Access Compliance Report Public Rights-of-Way (Curb Ramps)

Intersection ID: N/A Main Street: S BREVARD ST **Cross Street: E 3RD ST** Location: N ADA ID: 6EC42649D8C3 Ramp Type: Perp Initial Pass/Fail: Fail **Overall Compliance: No Severity Score:** 10

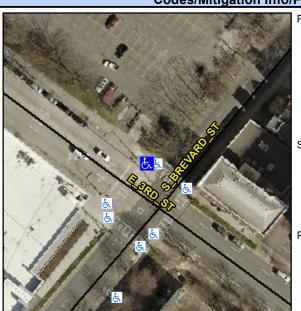
E 3RD ST Street 1 Name Stop Condition-Street 2 Signal Street 2 Name N/A Stop Condition-Street 1 N/A Possible Solutions: Remove & Replace Entire Ramp. Surveyor Notes: N/A PROW/ADA: Not Found, R304.5.1, R304.5.3

Field Measurements/Component Compliance						
Compliance Description		Data	Comp	liance	Description	Data
N/A	Ramp Length (in)	62.0	Yes	Ramp	Slope (%)	6.5
No	Ramp Width (in)	44.0	No	Ramp	XSlope (%)	2.5
N/A	Flare Type LT	N/A	N/A	Flare ⁻	Гуре RT	N/A
N/A	Flare Slope LT (%)	N/A	N/A	Flare	Slope RT (%)	N/A
N/A	Flare Traversable LT?	No	N/A	Flare ⁻	Traversable RT?	No
N/A	Landing Length (in)	N/A	N/A	DWS	Provided?	N/A
N/A	Landing Width (in)	N/A	N/A	DWS	Contrast?	N/A
N/A	Landing Slope (%)	N/A	N/A	DWS	Length (in)	N/A
N/A	Landing X Slope (%)	N/A	N/A	DWS	Full Width?	N/A
N/A	Landing Curb? (Y/N)	N/A	N/A	DWS	Offset (in)	N/A
N/A	Shared Landing?	N/A				
N/A	Gutter Ponding?	N/A	N/A	Gutter	Slope (%)	N/A
N/A	Gutter Lip Ht (in)	N/A	N/A	Gutter	X Slope (%)	N/A
N/A	Painted X Walk1?	Yes	N/A	Painte	d X Walk2?	N/A
	X Walk 1 Direction	To SW		X Wall	k 2 Direction	N/A
N/A	X Walk 1 Width (in)	103.0	N/A	X Wall	k 2 Width (in)	N/A
	X Walk 1 Slope (%)	2.1		X Wall	k 2 Slope (%)	N/A
